AGENDA
PLANNING AND ZONING COMMISSION MEETING
CITY OF CREVE COEUR, MISSOURI
MONDAY, JUNE 15, 2020

**APPLICATION TO PLANNING AND ZONING COMMISSION
#20-002 & #20-010: BOUNDARY ADJUSTMENT, SITE DEVELOPMENT
PLAN AND CONDITIONAL USE PERMIT FOR QUIKTRIP GAS STATION
WITH CONVENIENCE STORE AT 11004, 11026, AND 11032 OLIVE
BOULEVARD AND 825 AND 827 GRAESER ROAD, AND THE
REDEVELOPMENT OF THE ADJACENT RETAIL CENTER
AT 11032 AND 11056 OLIVE BOULEVARD**

RE: Responses to Planning & Zoning Commission Comments & Questions
Proposed QuikTrip #613

WB-50 DELIVERY TRUCK MOVEMENT EXHIBIT
OLIVE ENTRY - GRAESER EXIT

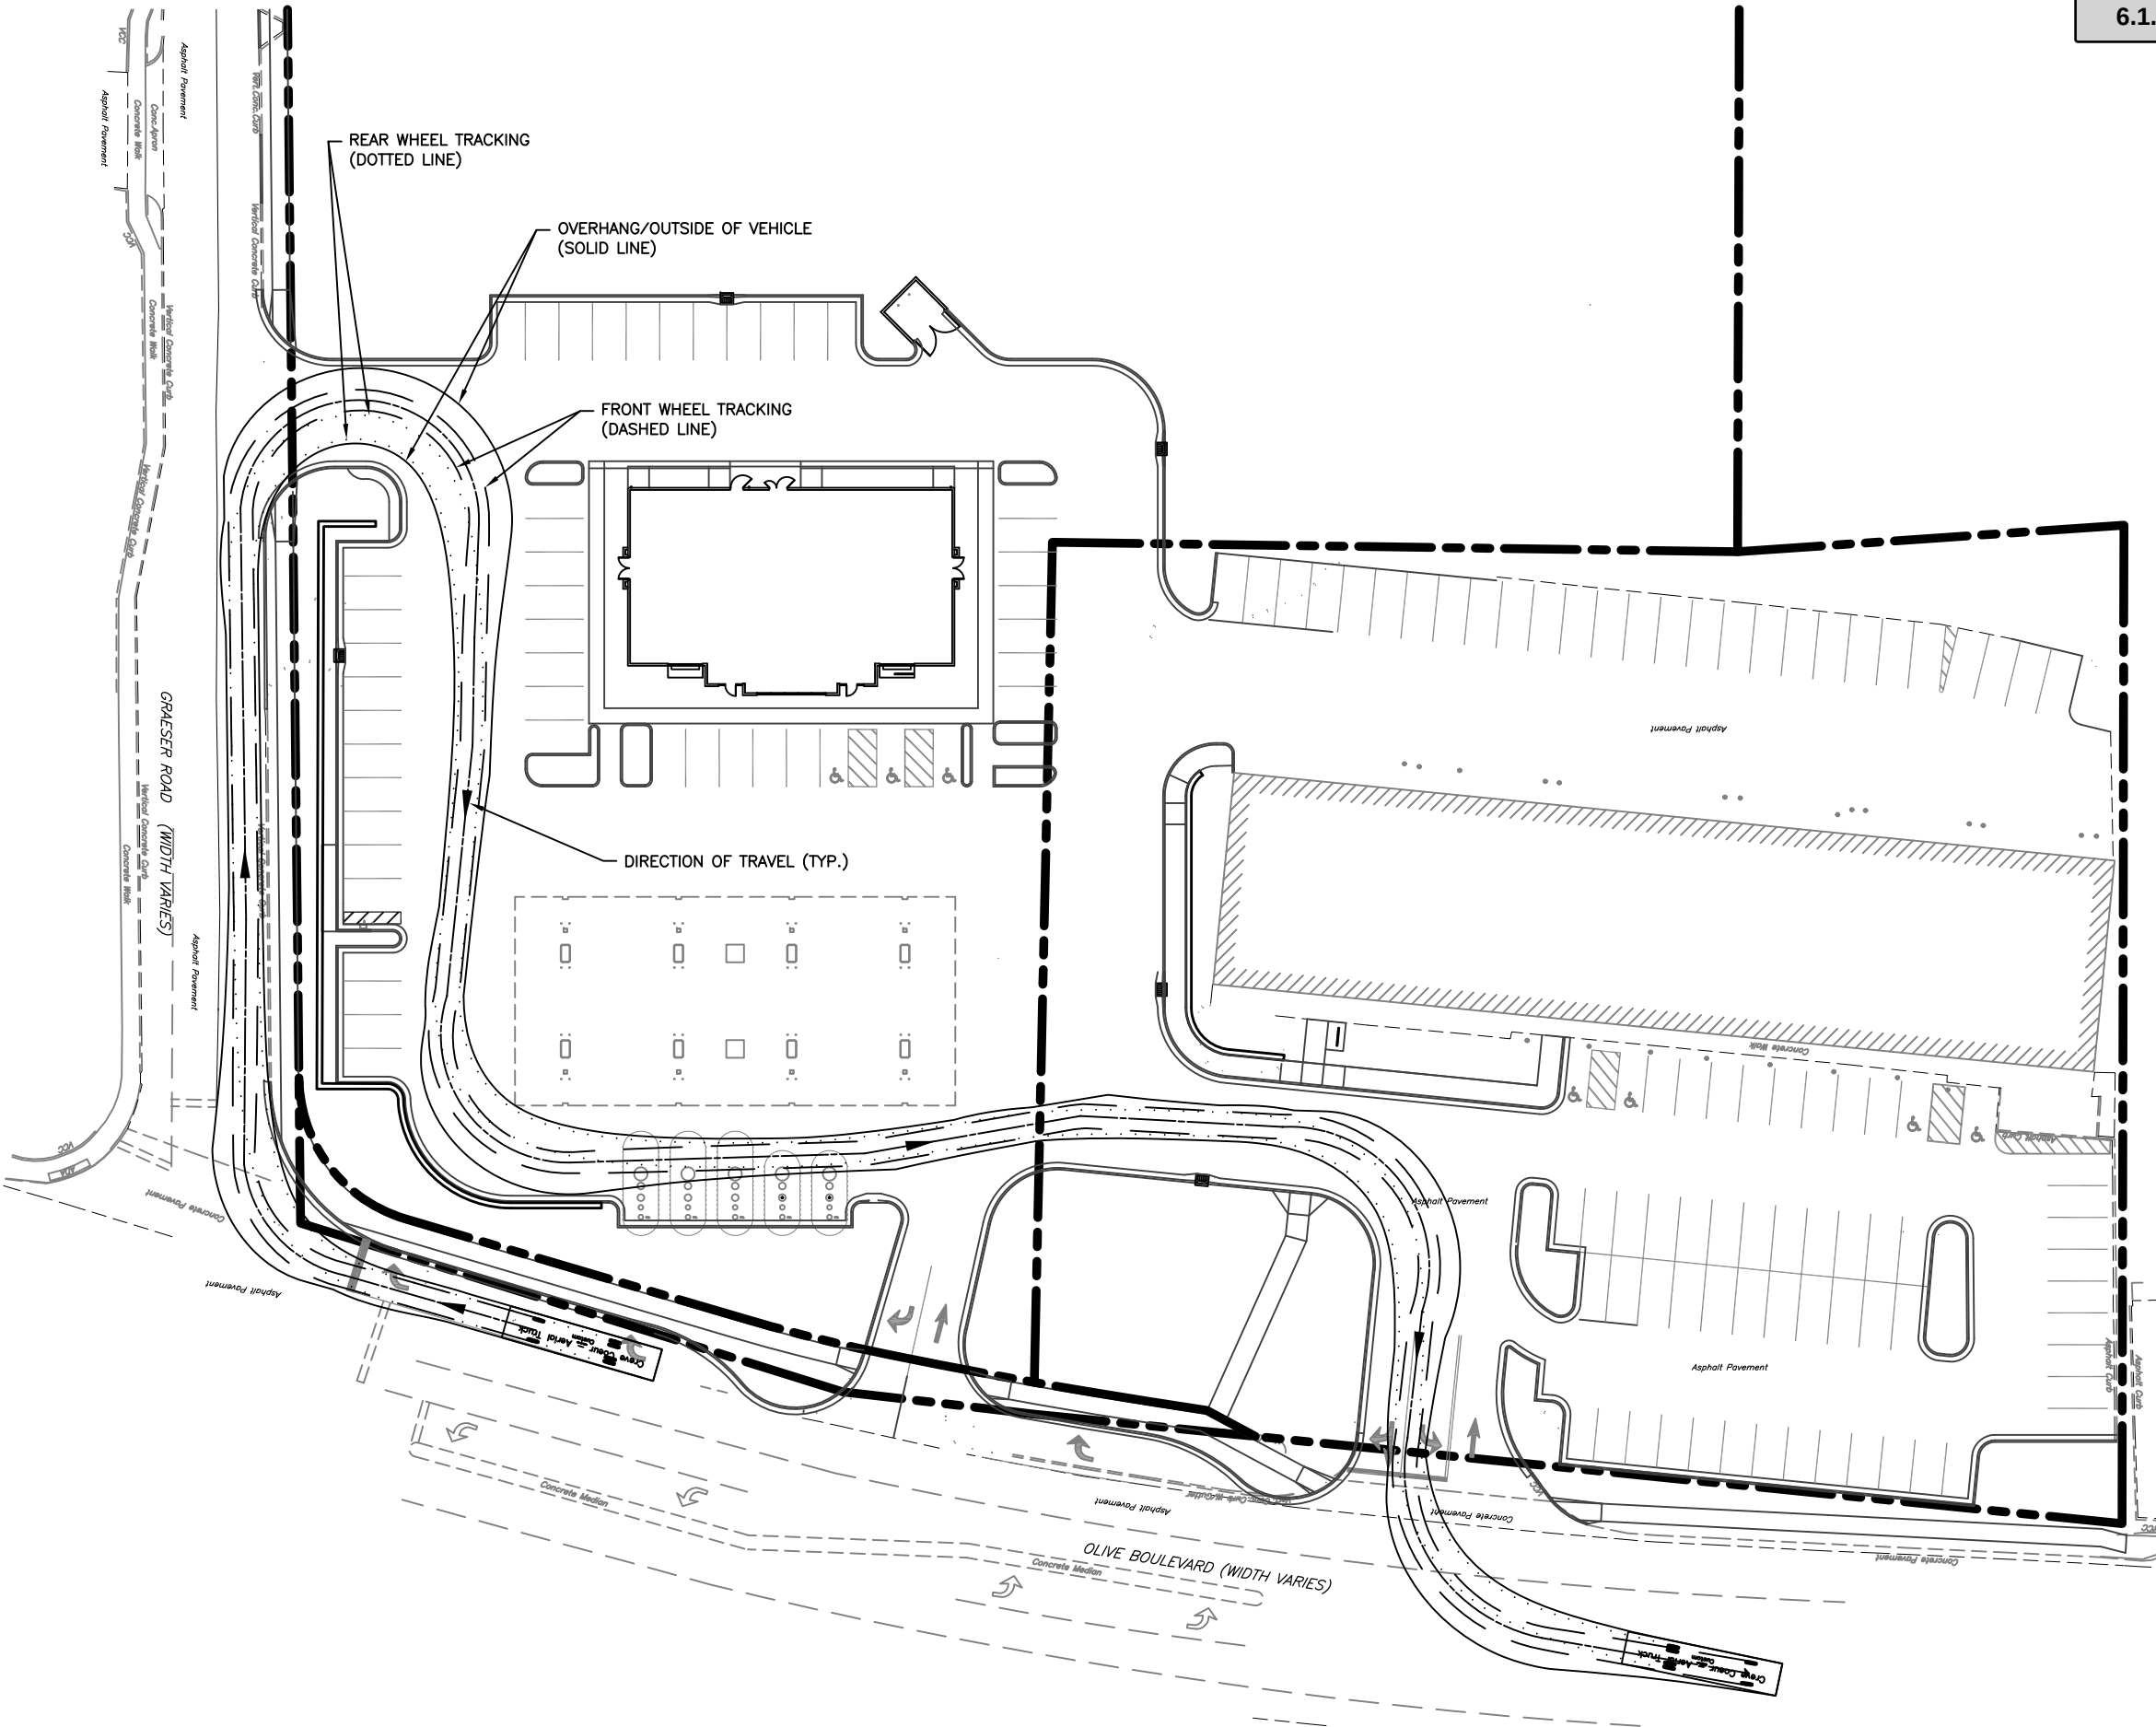
According to information provided by QT and CBB, they have adjusted the curb radius to better accommodate a turning truck. The Applicant has indicated a willingness to work with the City on scheduling the deliveries of the trucks to avoid rush hour/peak times. The Commission should discuss any further questions regarding deliveries with the Applicant.

1 CONCEPTUAL NORTH (FRONT) ELEVATION
A-1 | A-1 SCALE: 1/8" = 1'-0"

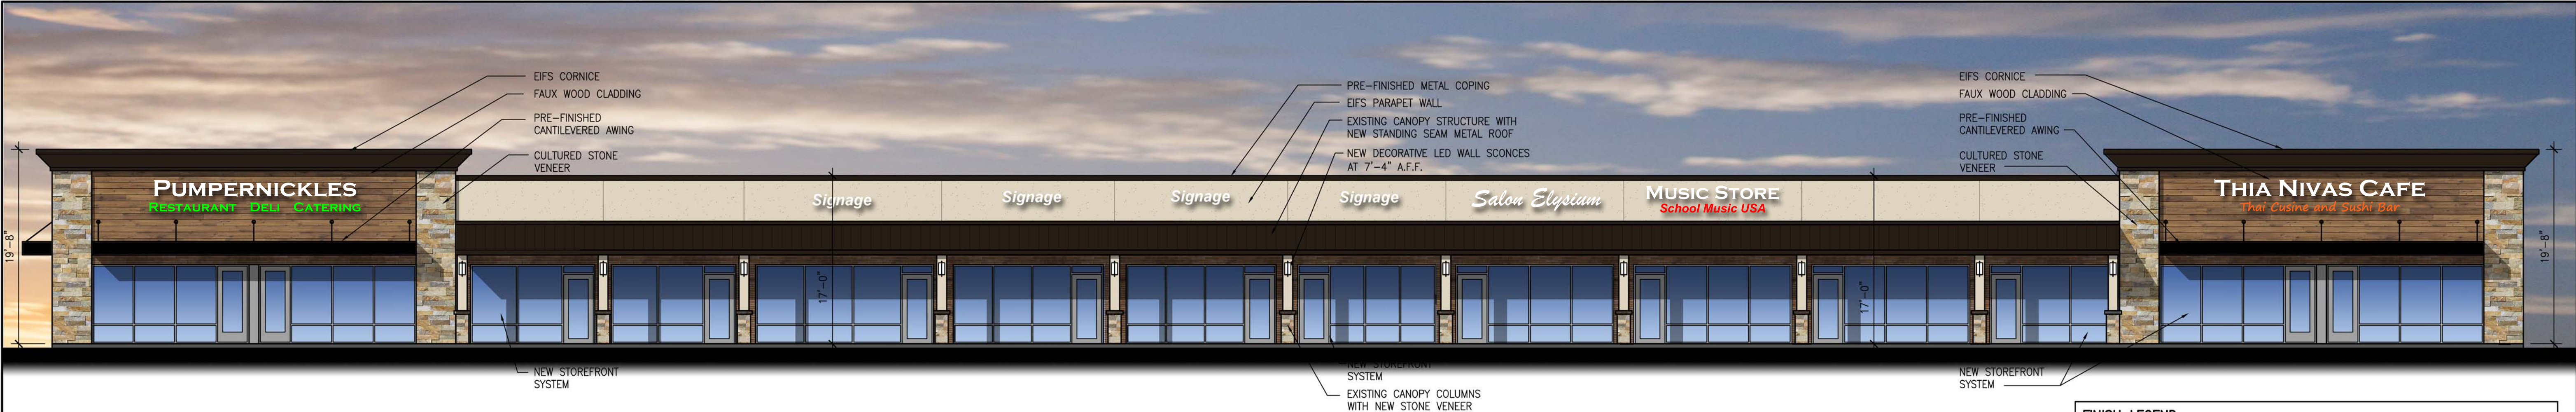
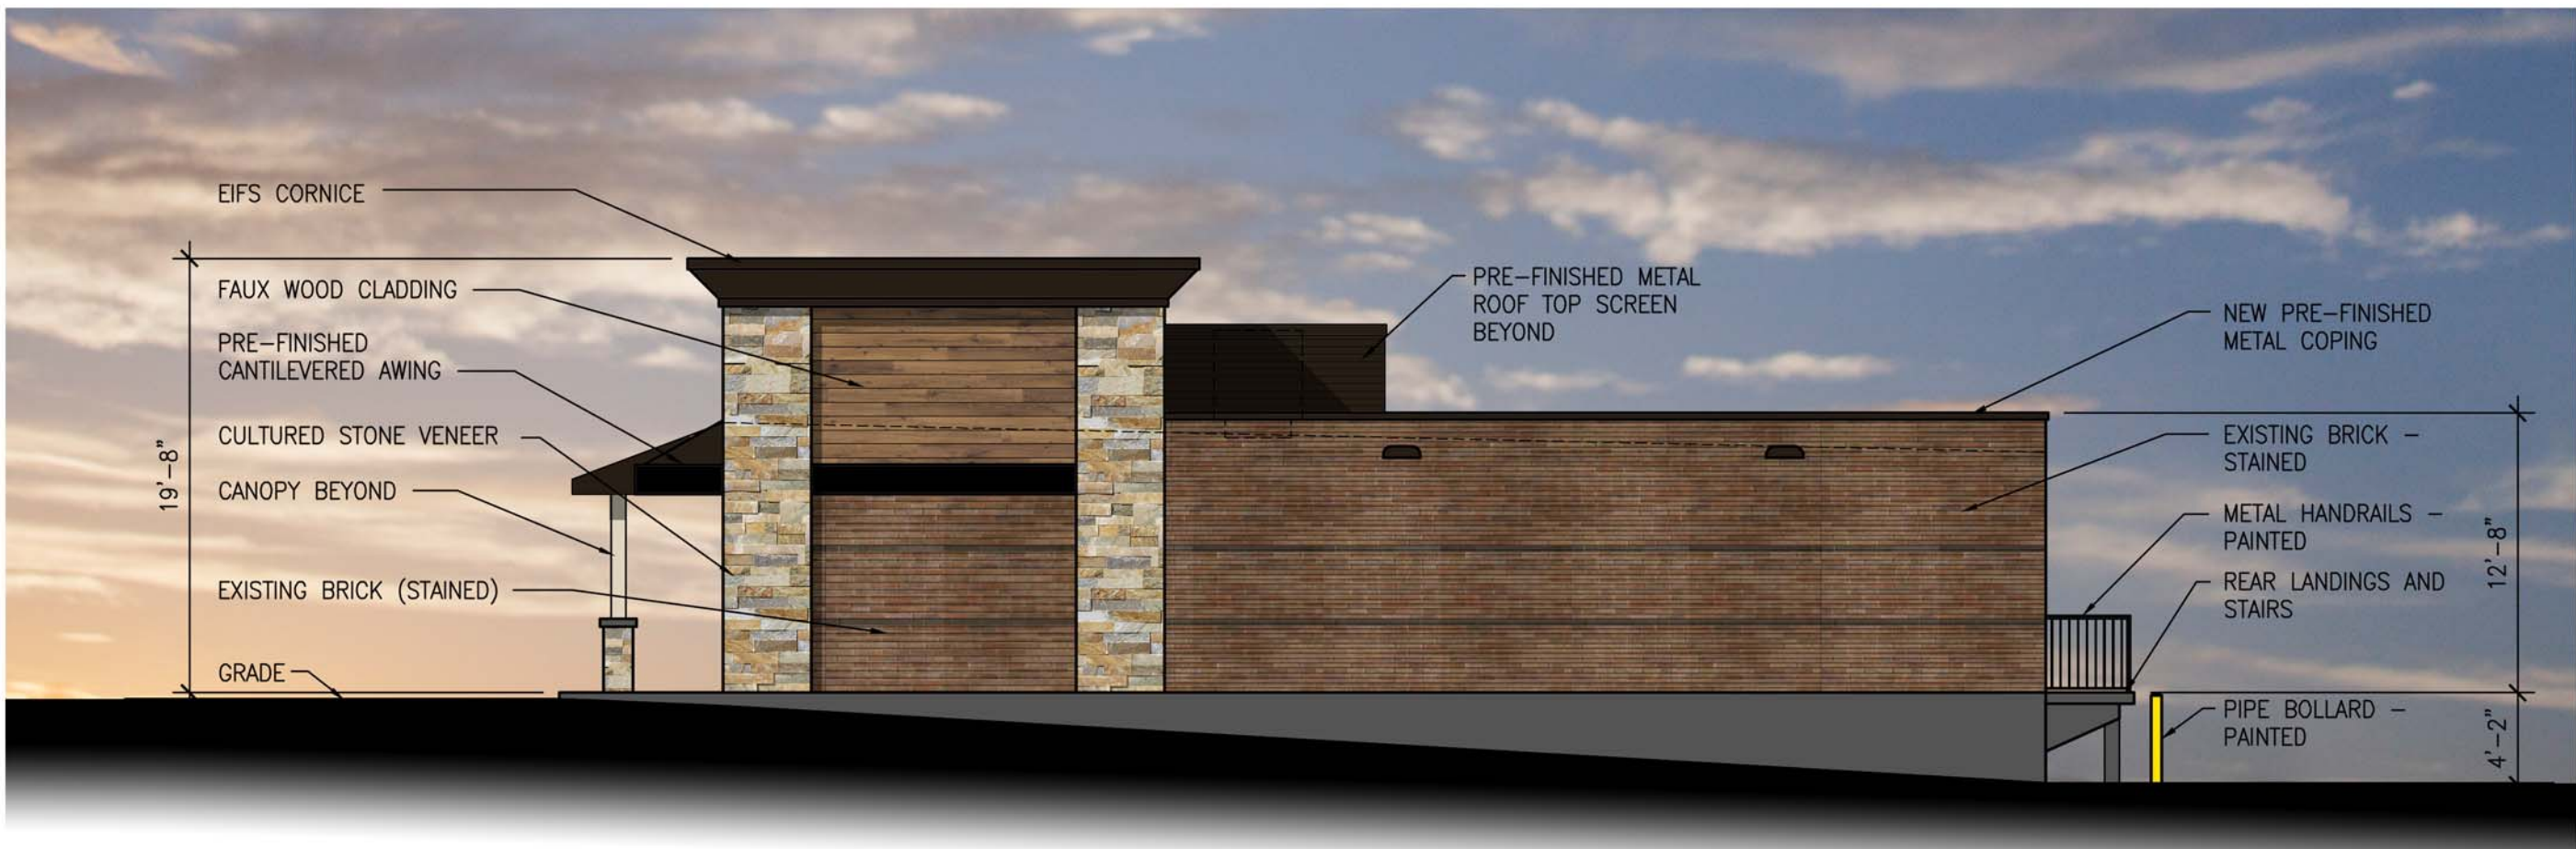
The Applicants have also submitted revised Retail Building elevation that show the screening of the mechanical roof-top equipment at the rear, as recommended in the prior Staff Report.

- Incorporate additional design elements for the buildings including carrying the stone all the way around the side tower elements and adding brick and/or stone for the full length of the canopy columns for the QT component and add screening of the rooftop mechanical units to the rear of the retail building.

PRELIMINARY DEMOLITION
PLAN

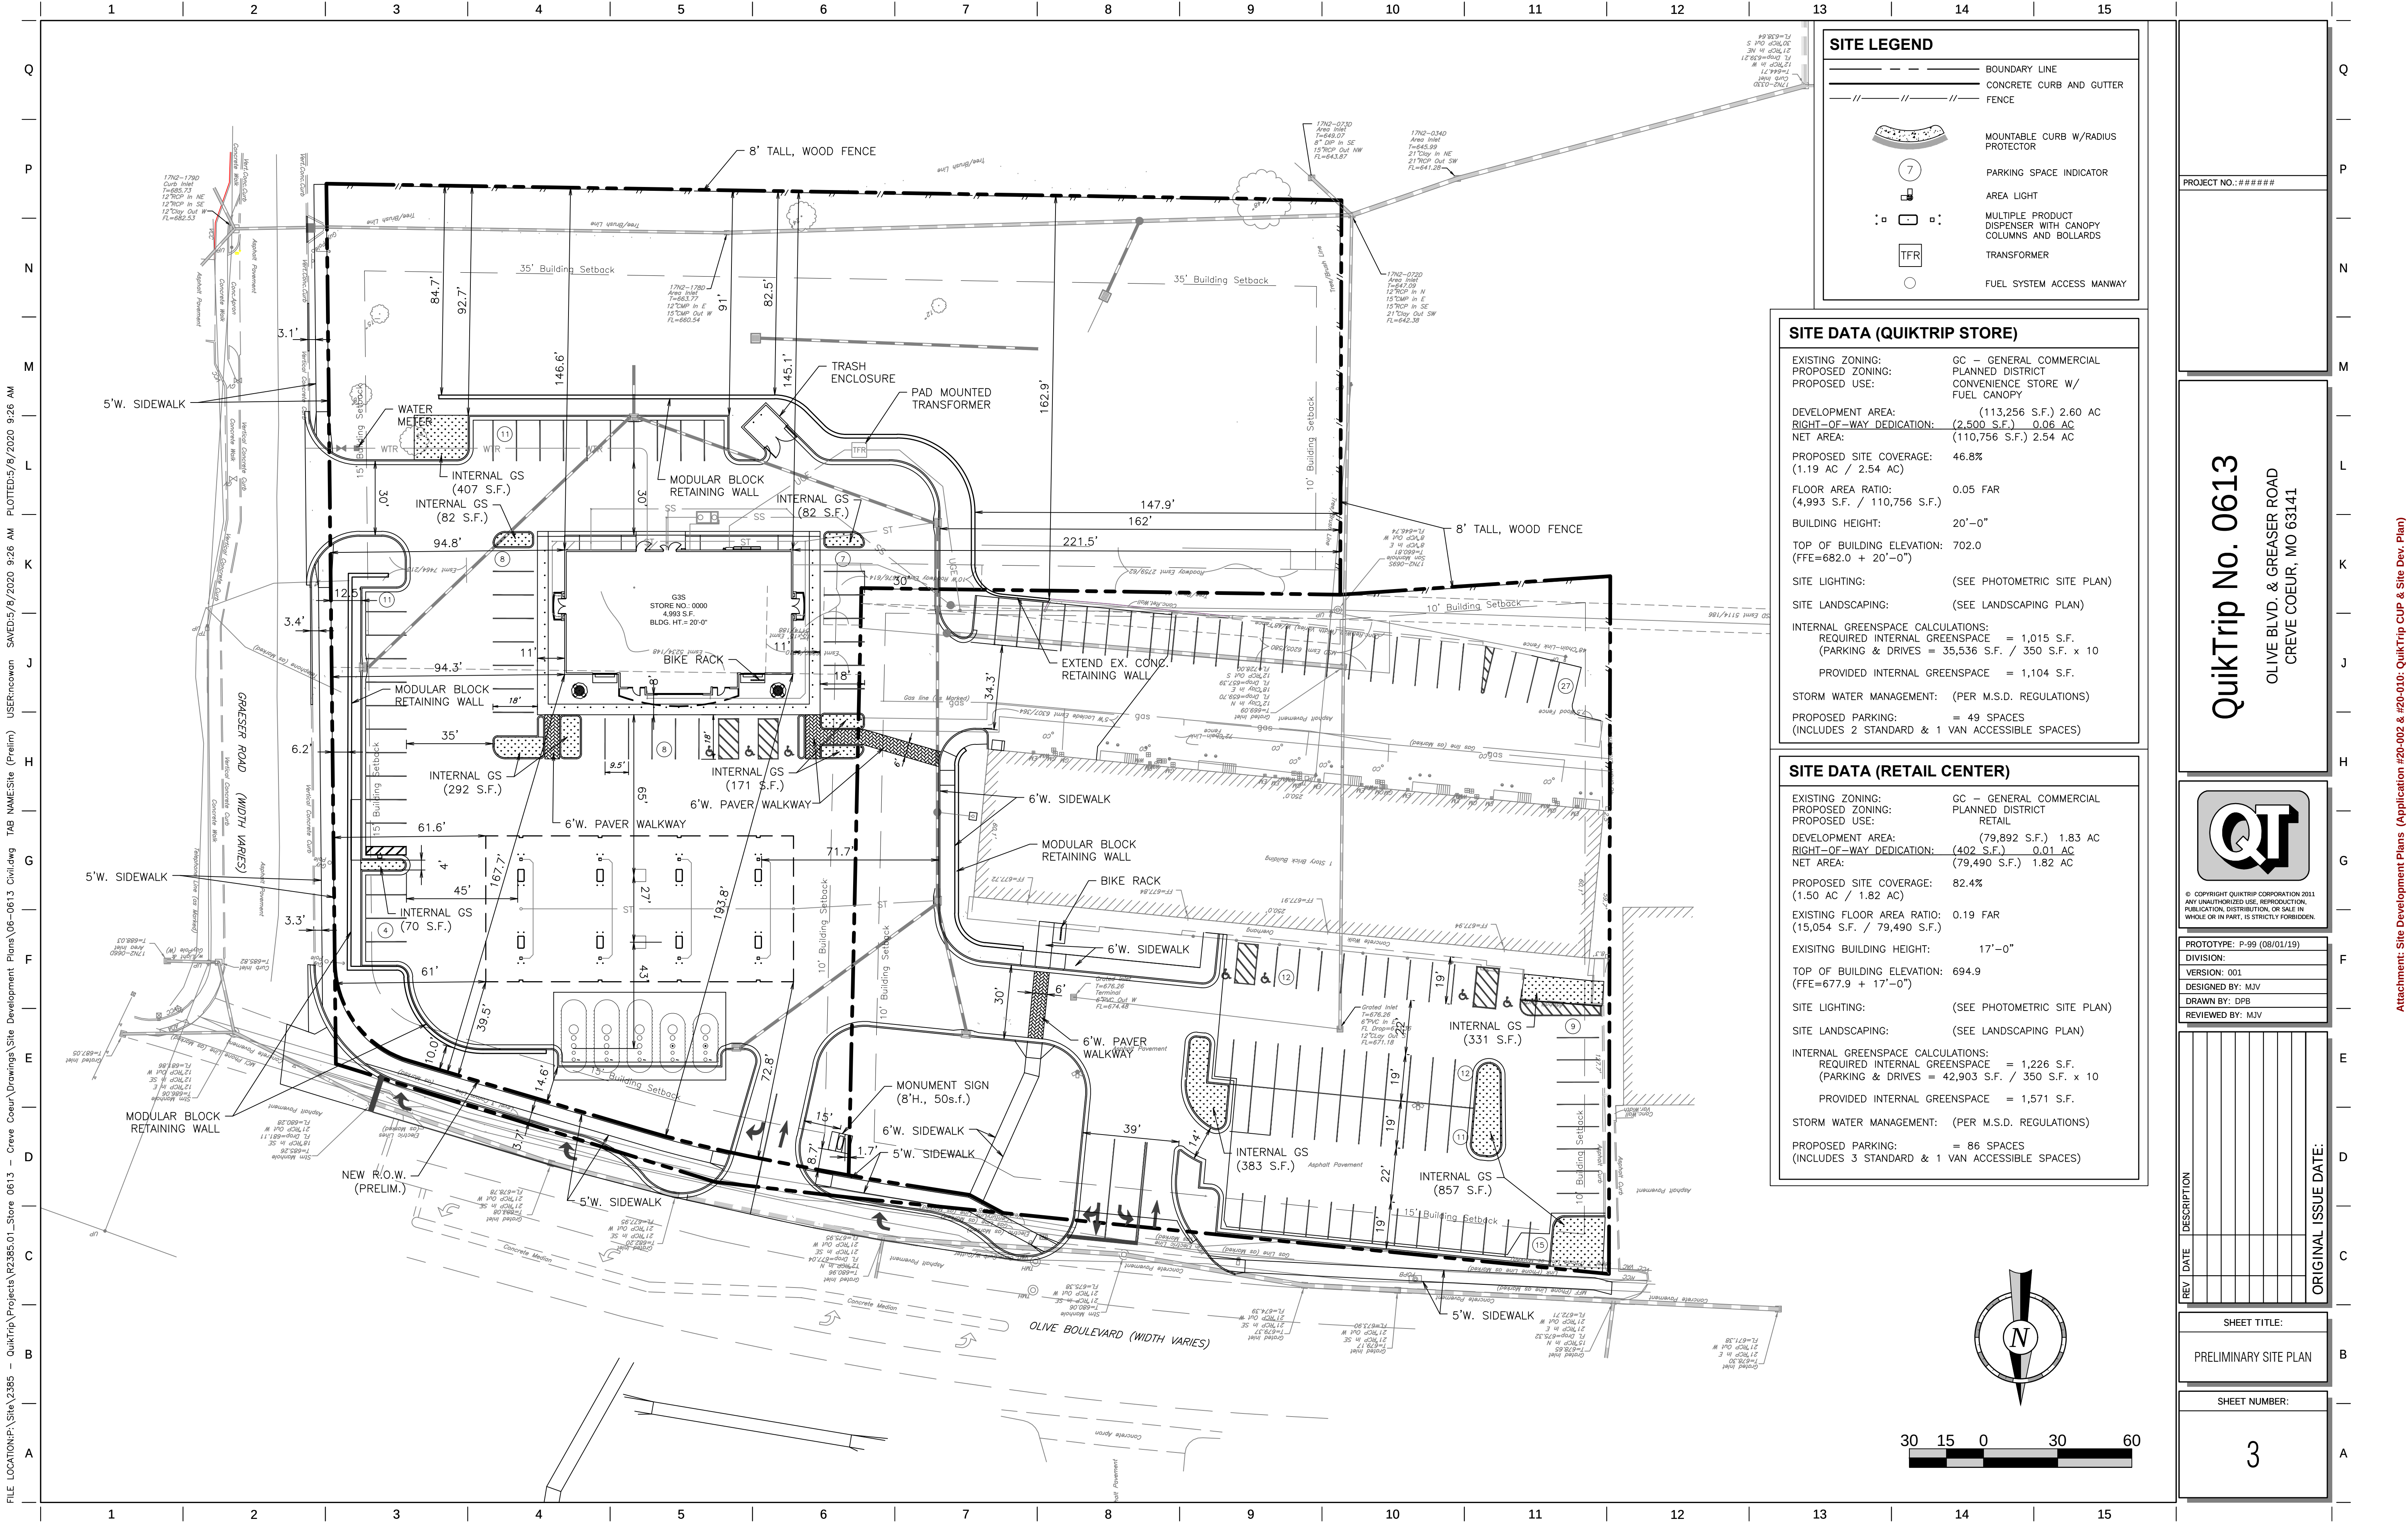
- "Demo" Plan seems to be a mislabeled, as it is showing existing and proposed development.
- The Site Plan should maintain or enlarge the existing greenspace and remove the two parking spaces proposed at the southwest corner along Olive Boulevard

Now that we have Preliminary Demolition Plan Sheet 2 and Renderings (Elevations), we can see how much of the formerly residential area is taken up by the proposed development. The parking lots eats 69 ft, the big trash enclosure more, and the retaining wall about 78 ft. What is left is a pair of soulless detention basins, separated from the Martin Grove homes by a flimsy wooden fence.
